Re: Paric Corporation Project No. 15051
15051-Webster University Interdisciplinary Science Building
CP-034 - ASI#27 Landscape - Pavers

Architect's Supplemental Instructions

Architect's ASI No: 027

Precast concrete pavers at north entry changes and extension of pavers along west edge of green roof.

(E) PLAN OF PAVERS AT NORTH AREAWAY

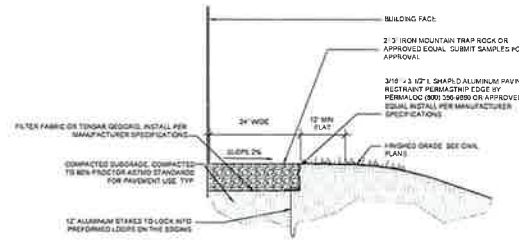
ASI #27 made the change from concrete at the north entry to pedestal pavers on a roof condition. The unique conditions in this area require a more complex design solution than a "one-size fits all". In working with Cannon directly, we arrived at the solution indicated in ASI #27.

Our bid documents have shown 12x24" dimension pavers throughout. ASI #27 introduced a 36" long paver to work with the cadence of the handrail posts (previously noted on Cannon's drawings as a 3'-0" long cap to match pavers). Beyond the extent of the cap previously shown, the 3'-0" length needs to extend to the concrete walk. This is why the short distance of these pavers are wider than the others. In conceiving this layout we discussed internally the contractor could potentially order all the same width and field cut the others to fit. We do not want to get into means and methods, so I can understand how the contractor sees this as 3 different size pavers now. We feel the added costs are justified and add value to the project.
